**ADDENDUM NUMBER:** TWO (02)

**ADDENDUM DATE:** December 19, 2016

**PROJECT:** New Modular Police Building  
Ahtahkakoop, Saskatchewan

DRAWING TITLE  
**CRAWLSPACE SKIRT SHEET STEEL UNDER ROOM 132**

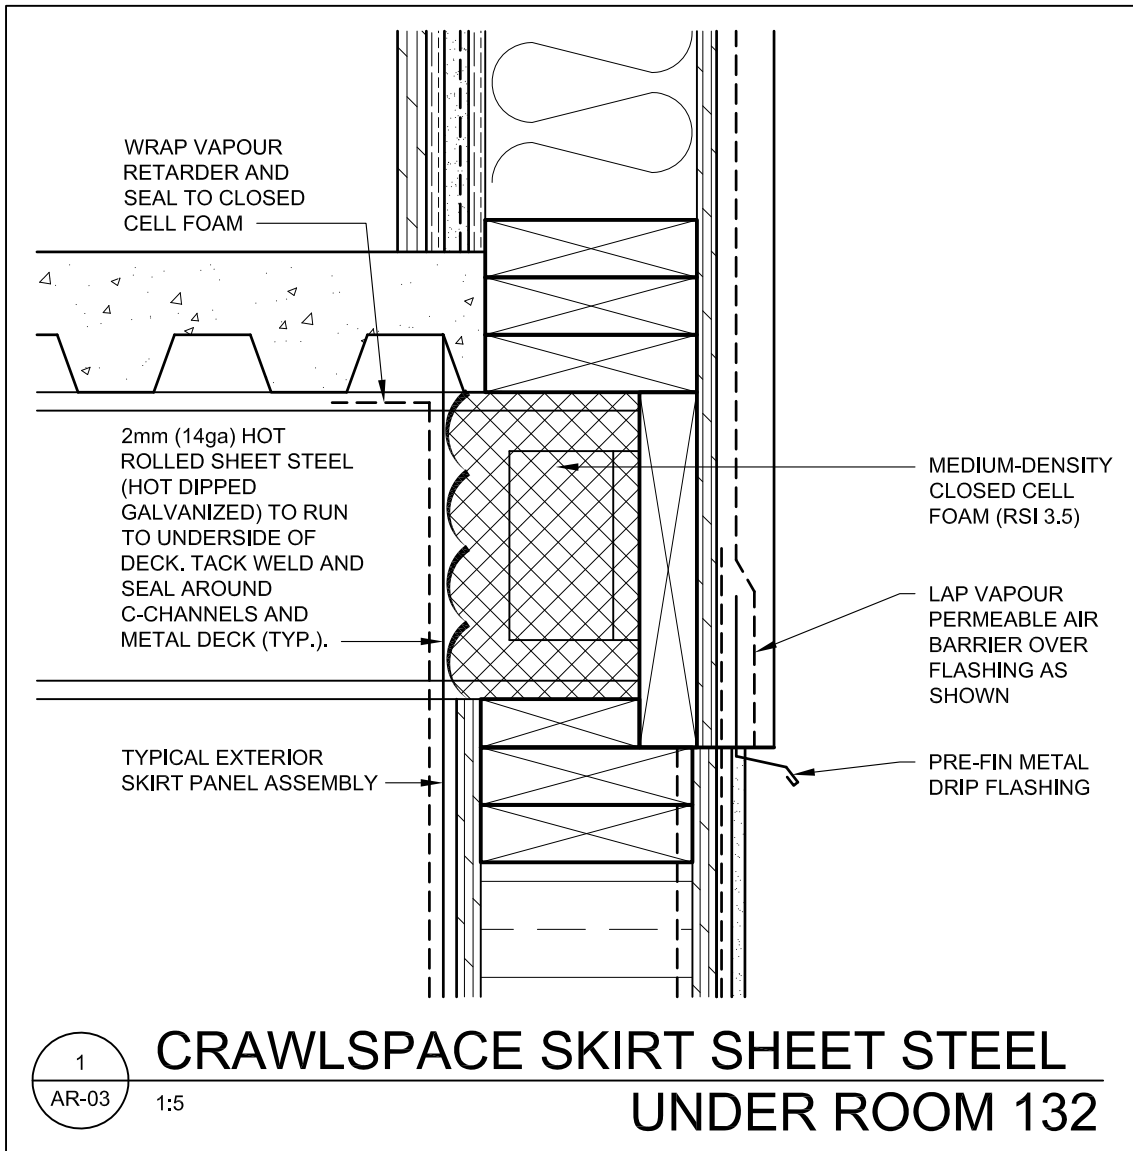
1. **Replace:** Note on detail 1 & 2 from “300mm deep granular structure (typ.). Remainder of backfill below to be free (typ.) – see Civil.” with “Provide granular structure as per Civil. Any remaining depth to be filled with free draining fill.”
2. **Add:** Detail on AR-03 attached. Detail is typical at crawlspace skirt connection around exterior perimeter of modules 17 and 18 to enclose spray foam insulation. A maximum gap of 5mm will be permitted between the sheet steel and other steel elements; any gap larger than this will have to be sealed with a fire stop material having a FSR of 25 or less.

## HANDRAIL CONNECTION DETAIL OPTION 'A'

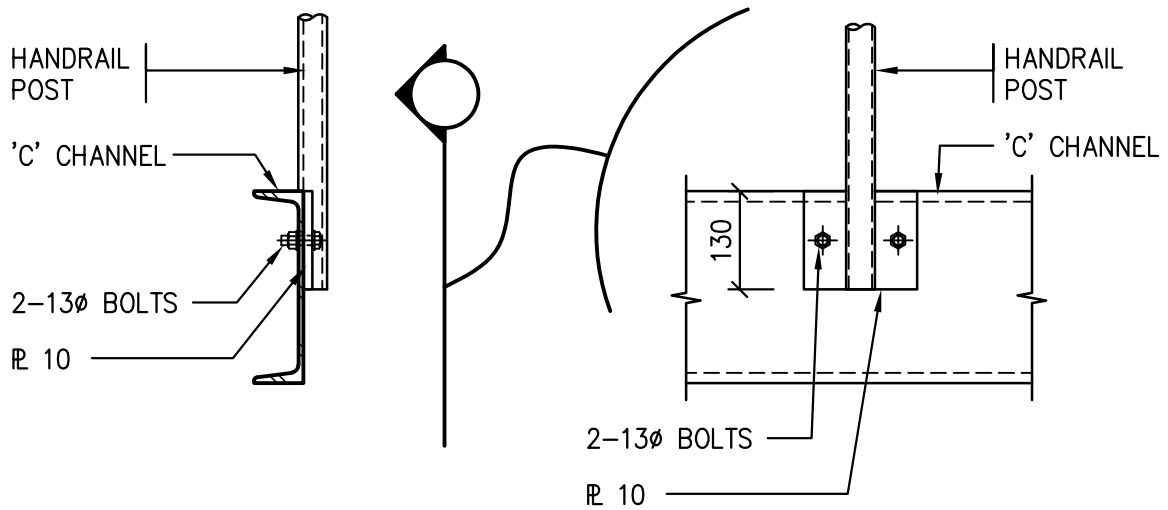
19. **Q:** Could you please provide the typical connections for railings posts to channel web, drawings S15 to S17 show railings are bolted to the side of channel frames. There are 2 types of connection need to be clarified, one way is for channel flange face against posts and the other is for channel flange face to the railing posts.

1. Refer to drawings S13, S14, S15, S16 & S17. Refer to Stair Notes. Refer to note #3; revise “HAND AND GUARDRAIL HORIZONTAL MEMBERS TO BE FROM DN38 STD. WALL HSS PIPE. VERTICAL MEMBERS TO BE FROM DN38 STD. WALL PIPE.” to read “HAND AND GUARDRAIL HORIZONTAL MEMBERS TO BE FROM DN. 40 STD 240MPa PIPE WITH OD=48.3. VERTICAL MEMBERS TO BE FROM DN. 40 STD 240MPa PIPE WITH OD=48.3.”
2. Refer to sketch SK4 for handrail connection details.

- A:** All guardrail to channel connections to be a bolt connection, bolted with 2-13dia bolts. See sketch SK4 for clarification.
20. **Q:** E6.1, please confirm if we can use native backfill in lieu of the specified granular backfill ovetop of the sand bedding.

Drawing title/Titre du dessin  
**CCTV-ALARM SYSTEMS AND  
 ACCESS CONTROL - AV CONDUIT  
 ROUGH-IN PLAN**

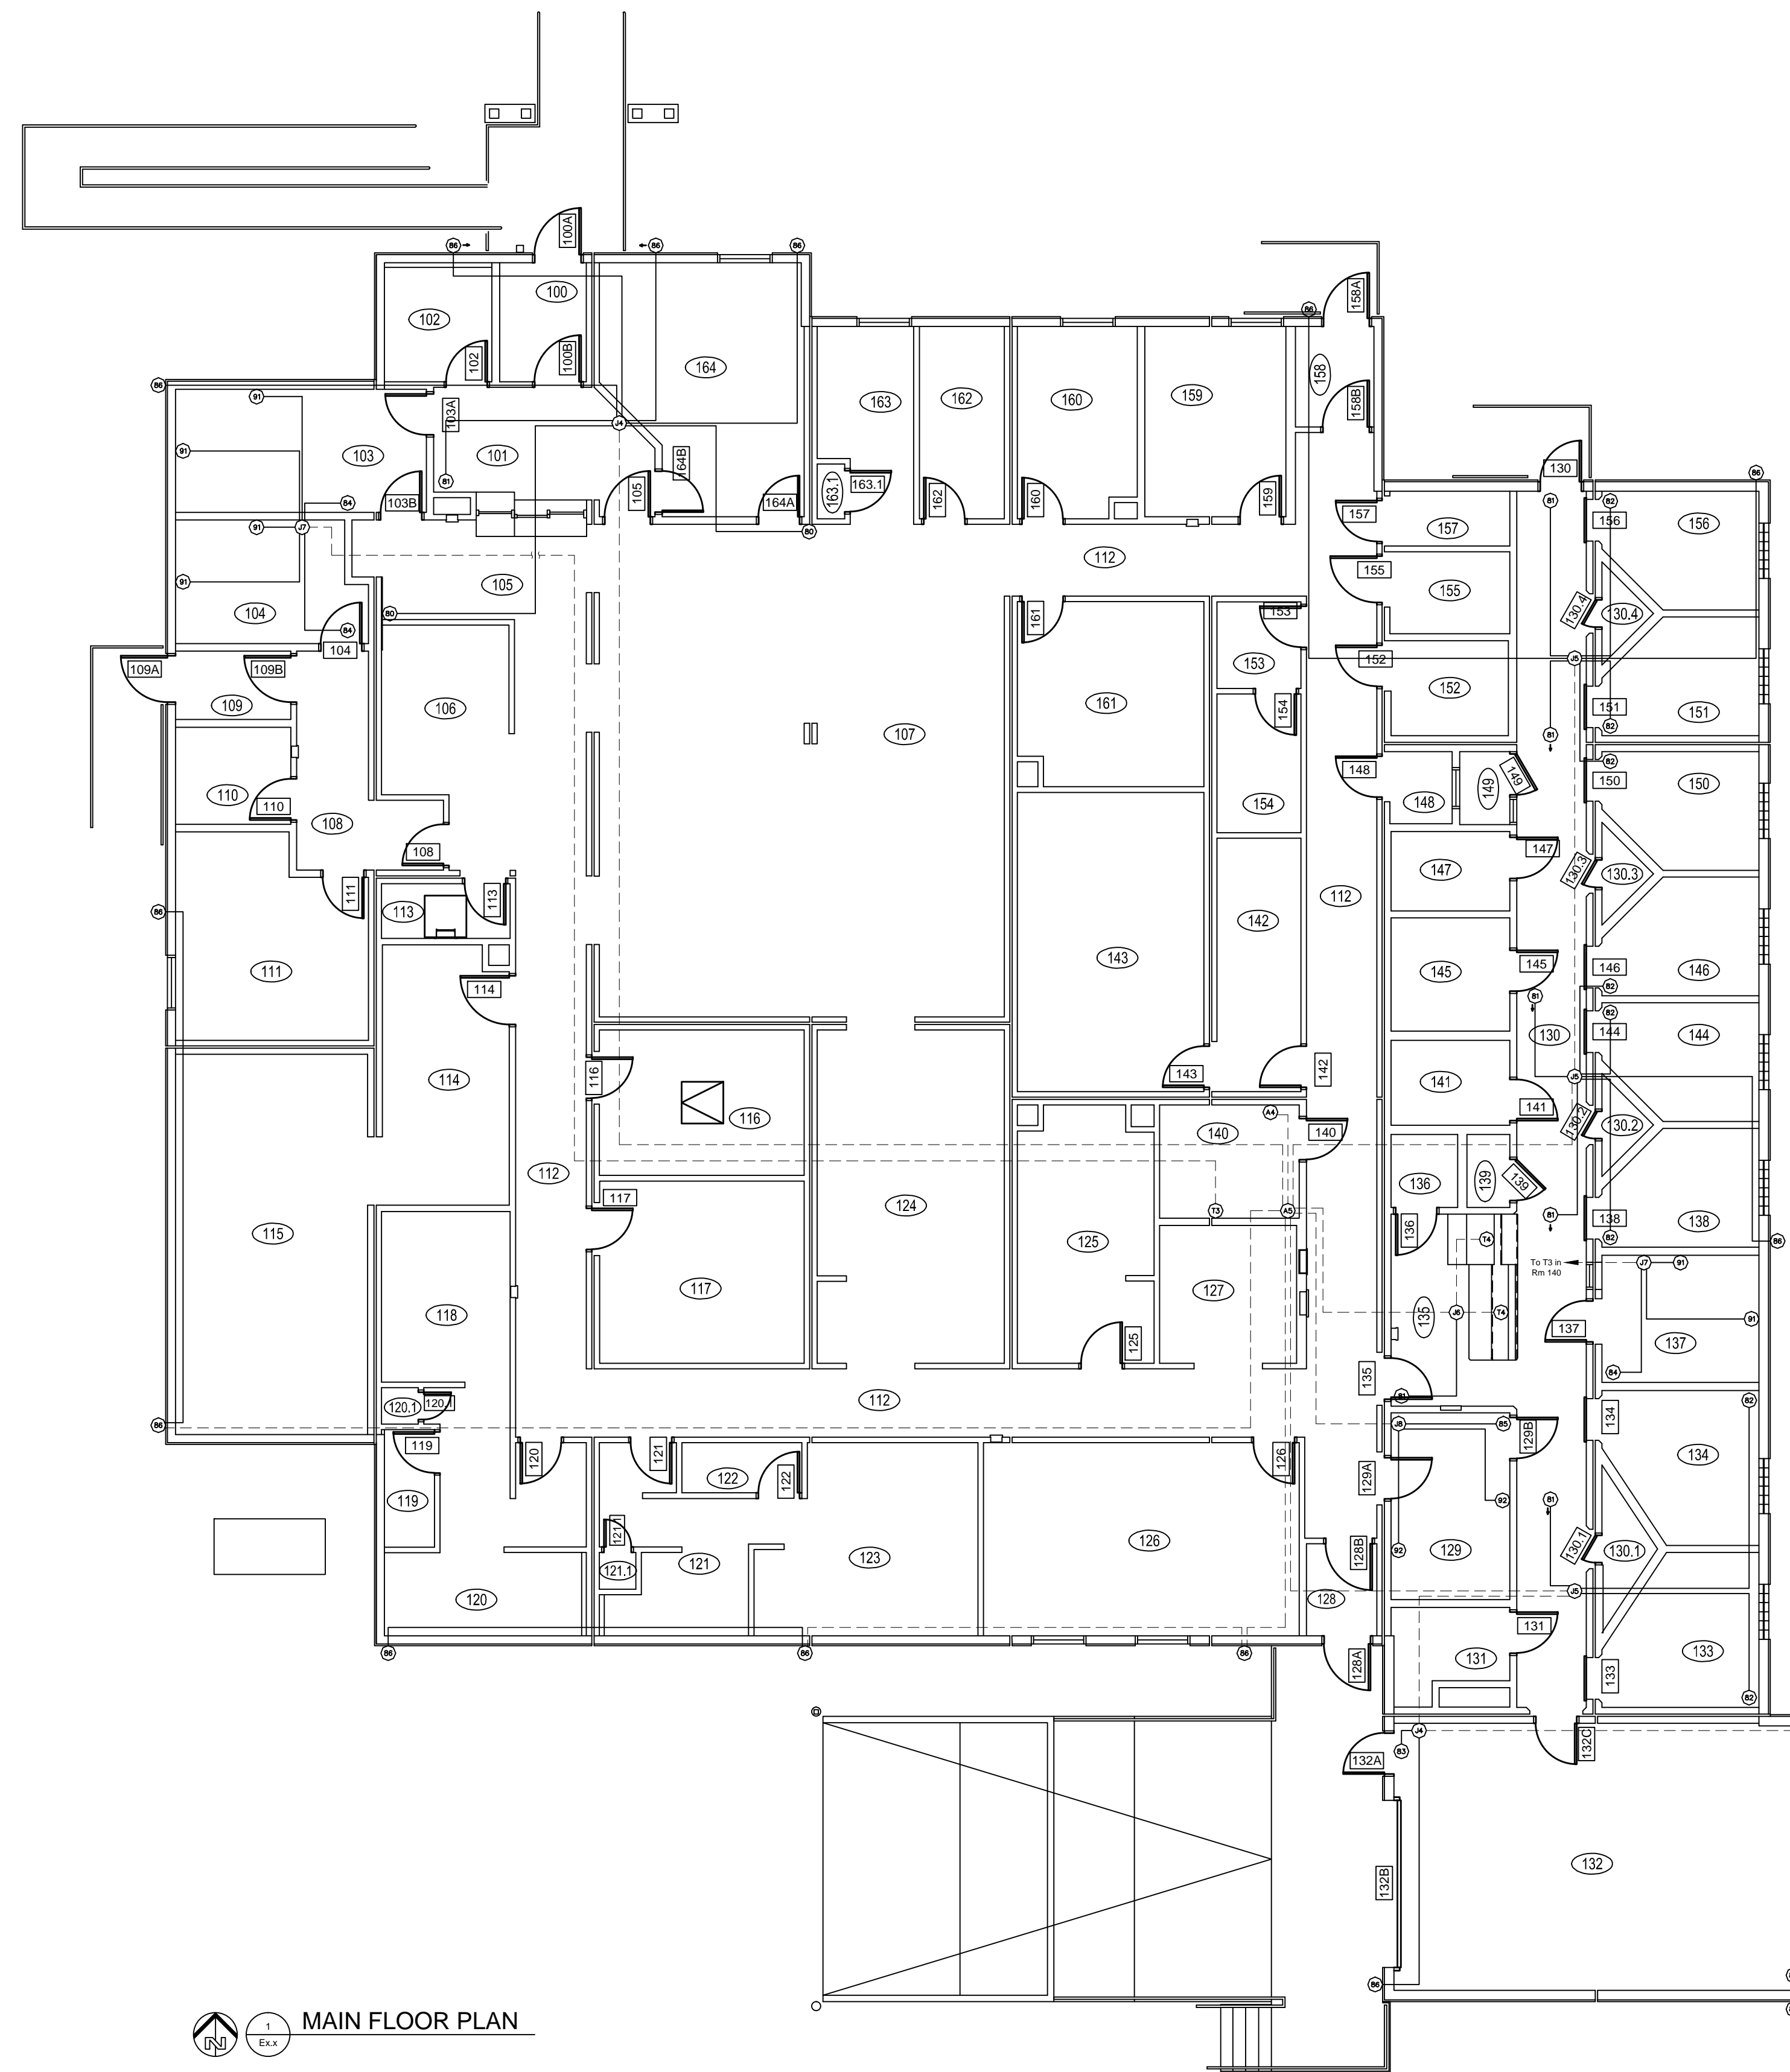
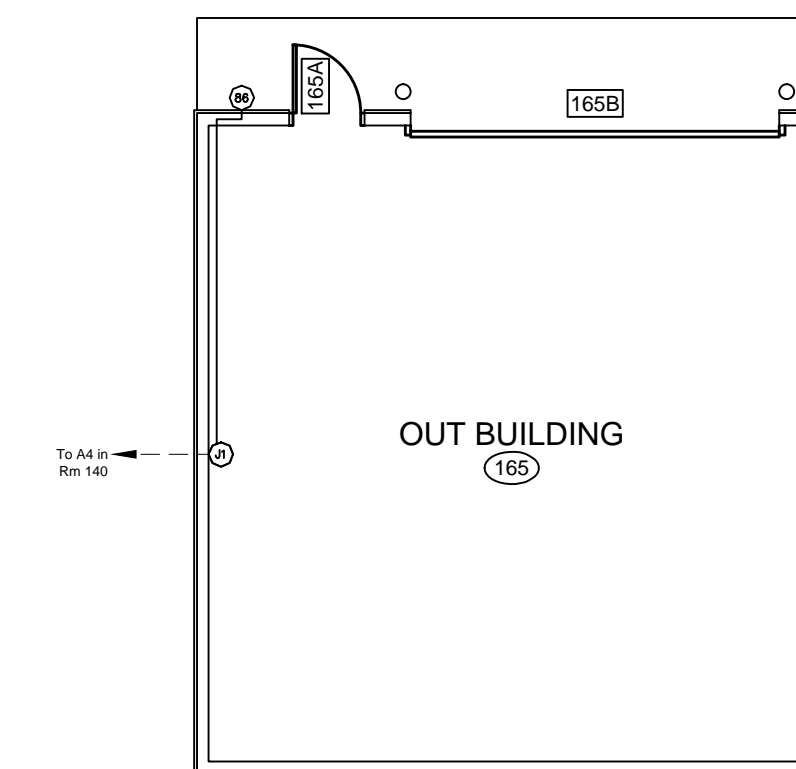
**E-2-3 REF. DRAWING E7.1 – CCTV-ALARM SYSTEMS AND ACCESS CONTROL – AV CONDUIT ROUGH-IN PLAN**

1. Refer to revised access control drawings E7.1R1.

Drawing title/Titre du dessin  
**CCTV-ALARM SYSTEMS AND**  
**ACCESS CONTROL - EAC & IDS**  
**CONDUIT ROUGH-IN PLAN**

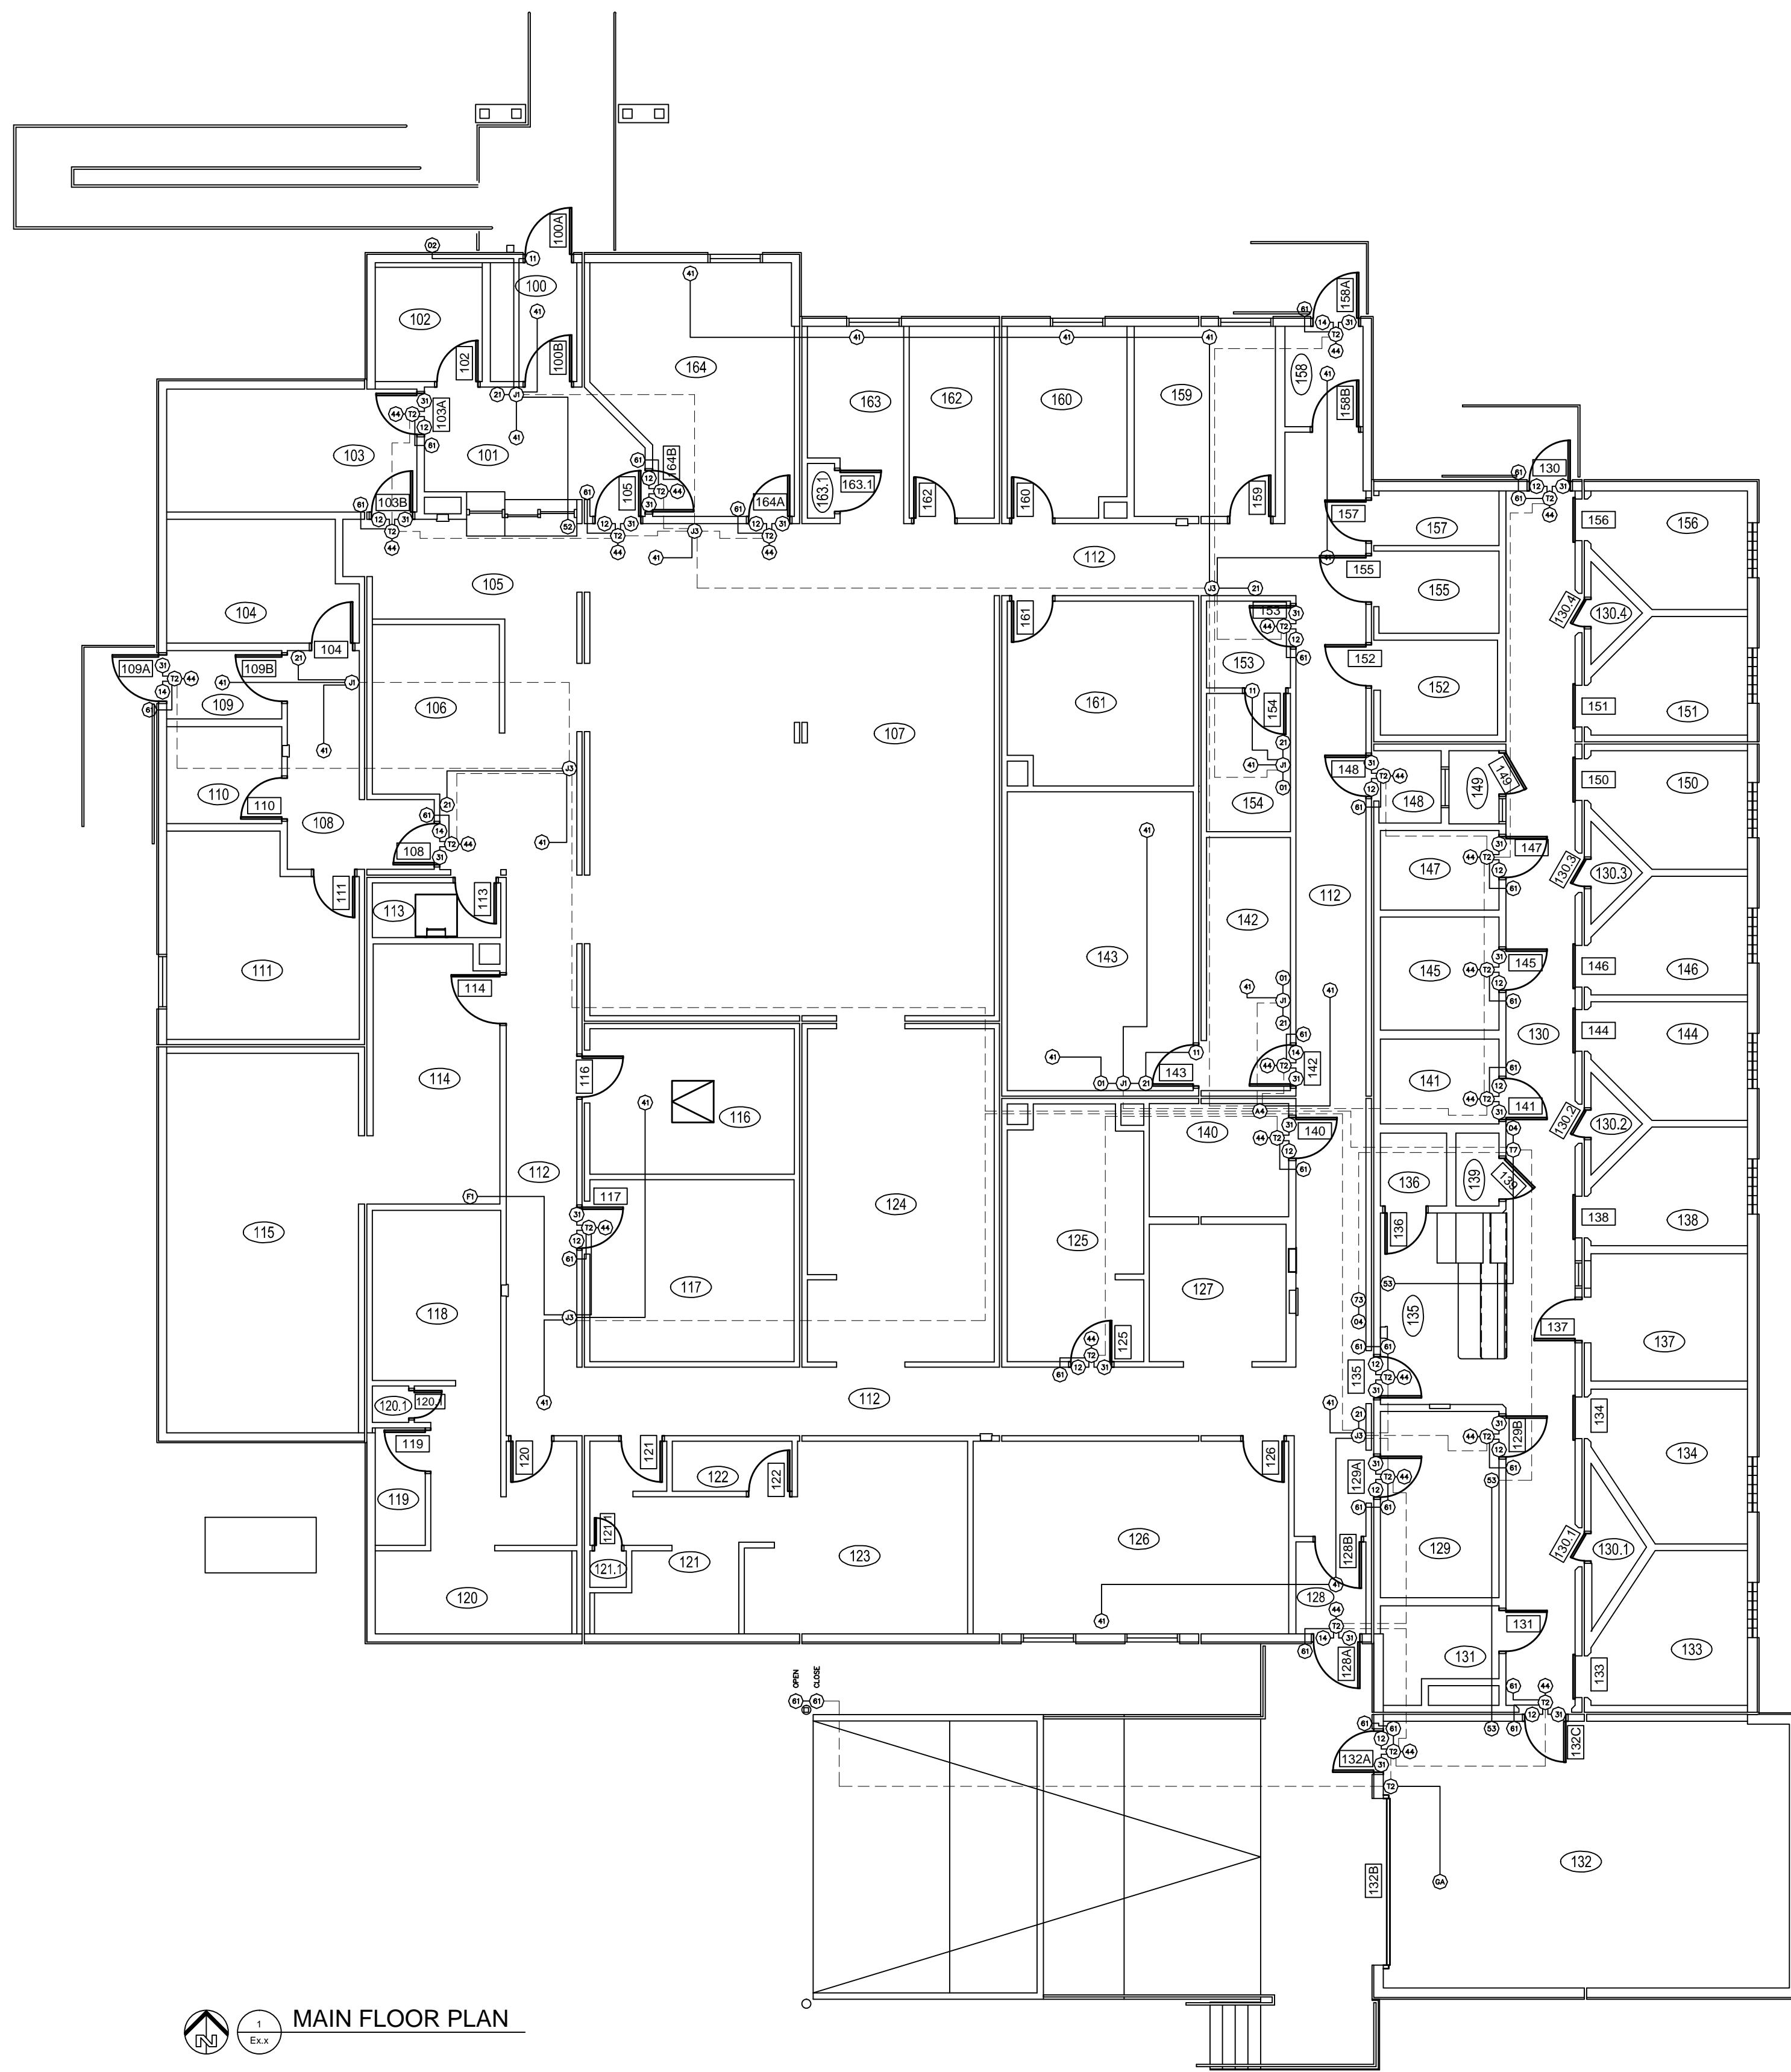
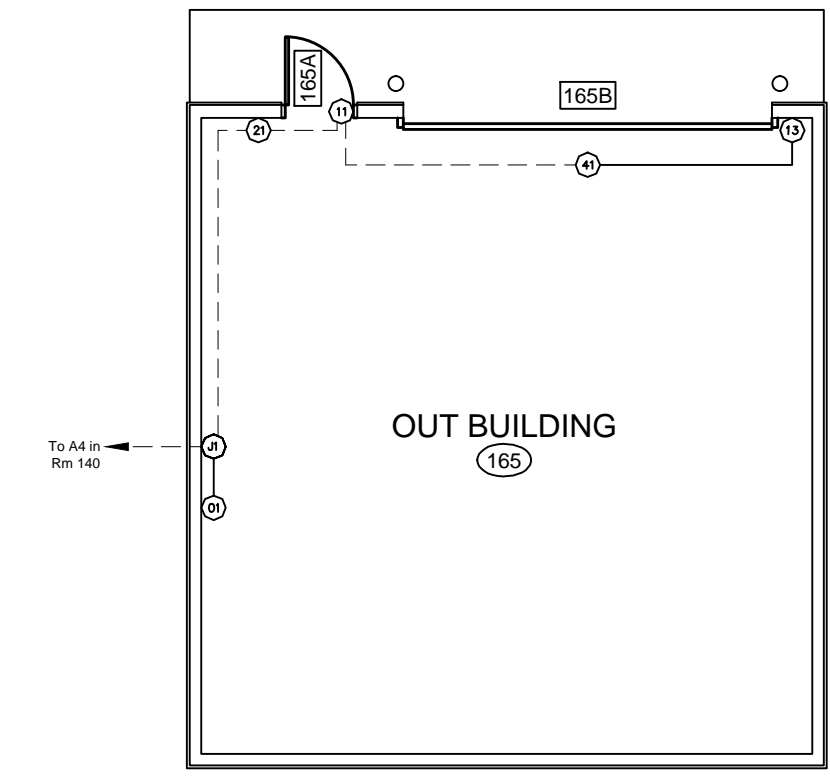
**E-2-4 REF. DRAWING E7.2 – CCTV-ALARM SYSTEMS AND ACCESS CONTROL – EAC & IDS CONDUIT ROUGH-IN PLAN**

1. Refer to revised access control drawings E7.2R1.
